Supplement to Product Change Notification PCN-2016-02-17

28.06.2018

Old version**New version**

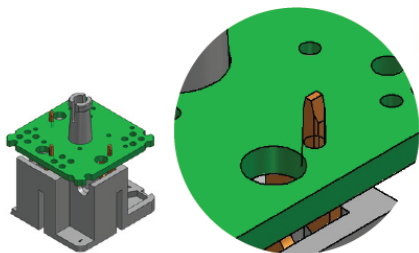
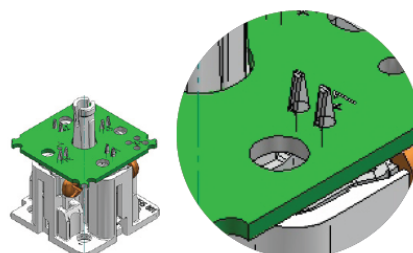
In order to match the latest PCB technology for all our circuits, Belden redesigned the PCB-assembling and the connection to the contact-bearer. To guarantee a better vibration-behavior and reliability of contact resistance and joints, the design has been up-graded to a double PressFit connection.

GDML 2016 LED 24 GB black or grey as well as GDML 2011 LED 24 GB black or grey

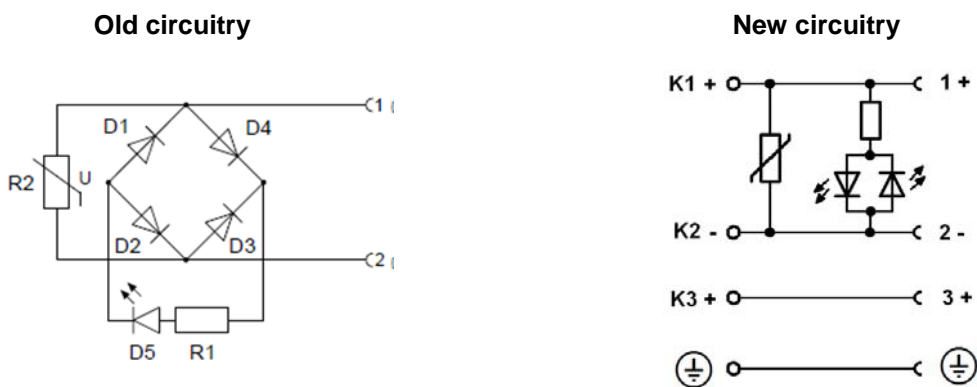
In the course of the PCB improvement defined protection circuitries were modified as well. So far bridge rectifiers and blocking diodes were used in combination with light-emitting diodes (LED) to ensure the functionality of the LED also with alternating current. At the same time reverse polarity protection was ensured with an antiparallel diode. In the scope of PCN-2016-02-17 the previous monopolar LEDs were replaced by bipolar LED versions, which can be operated with direct as well as with alternating current. A prior rectification is thus no longer necessary. Also, with the bipolar light-emitting diodes the risk of polarity reversal is no longer given as they enable a flexible connection. Due to the replacement of former monopolar LEDs by bipolar light-emitting diodes the following new circuit diagrams emerge:
